Response to Request for Further Information

PA.Reg.Ref.SD22A/0460

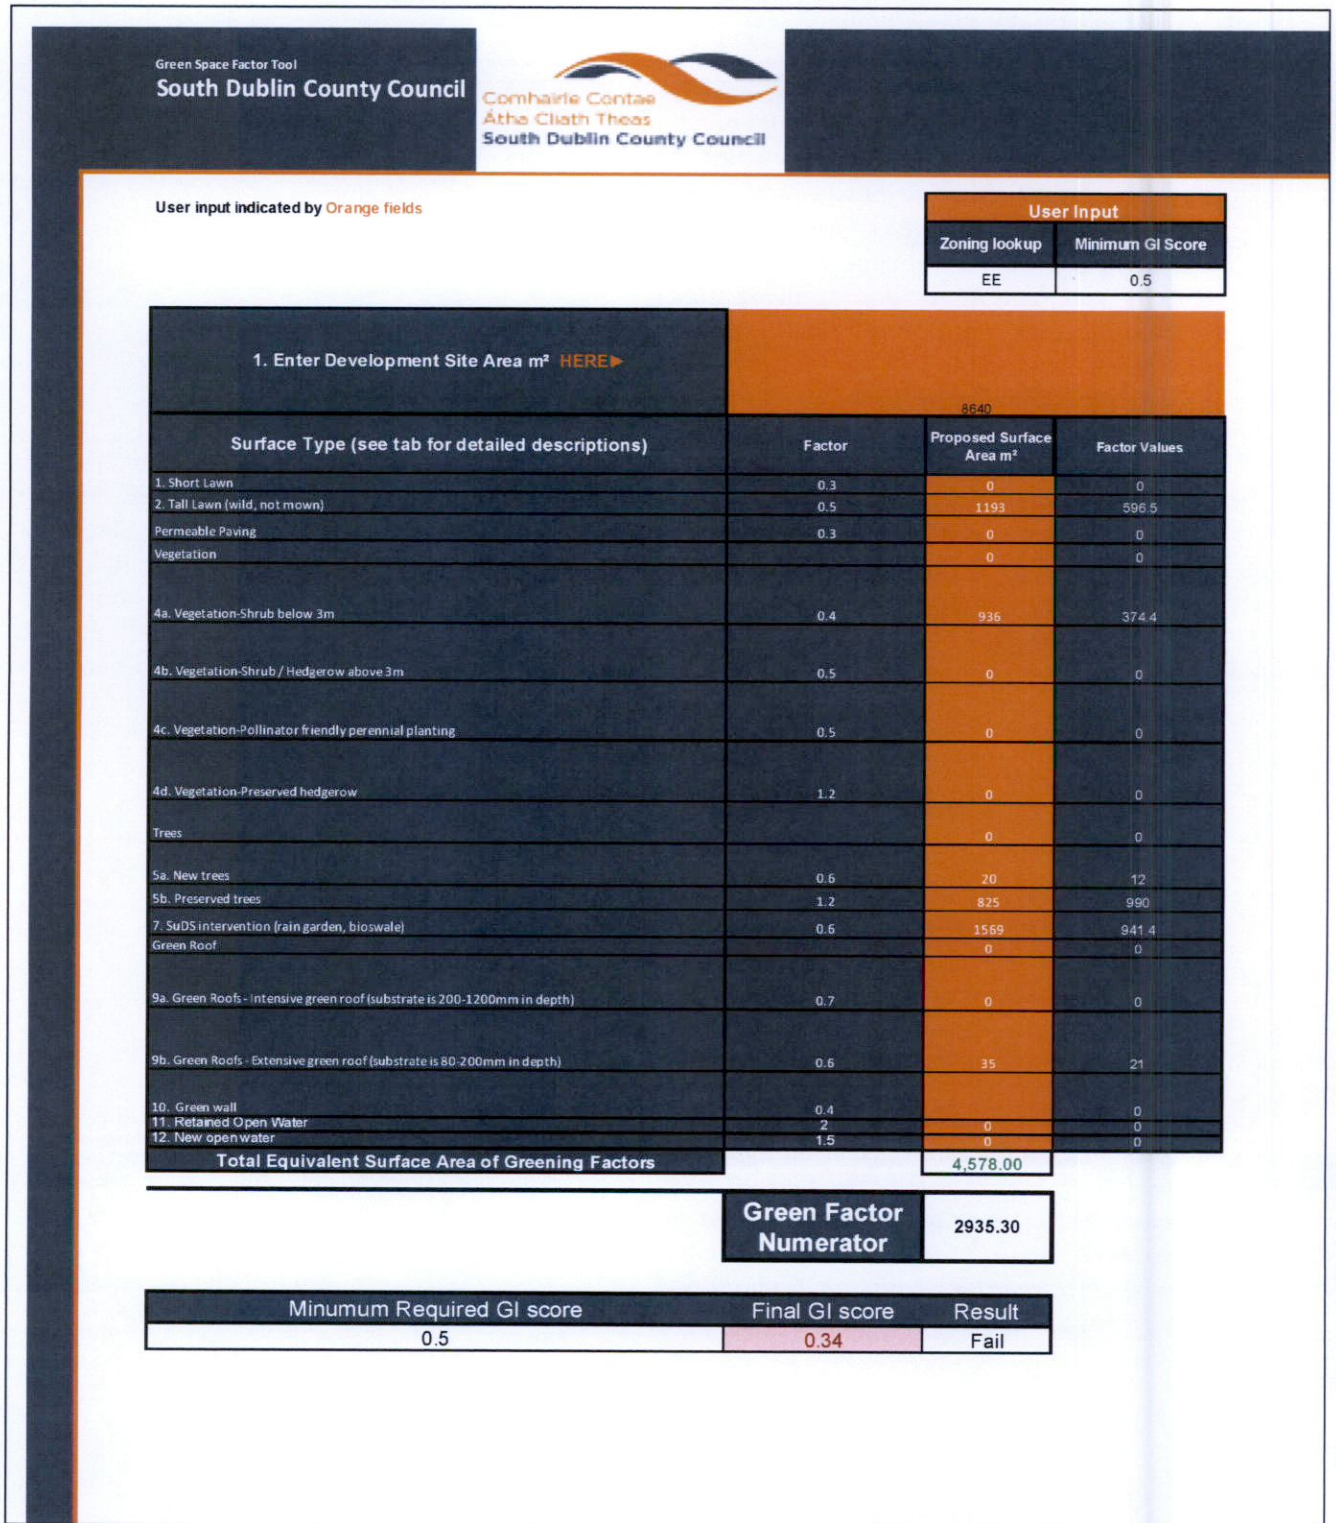
5.2.5 Response to Landscape RFI Item 4.1 (v)
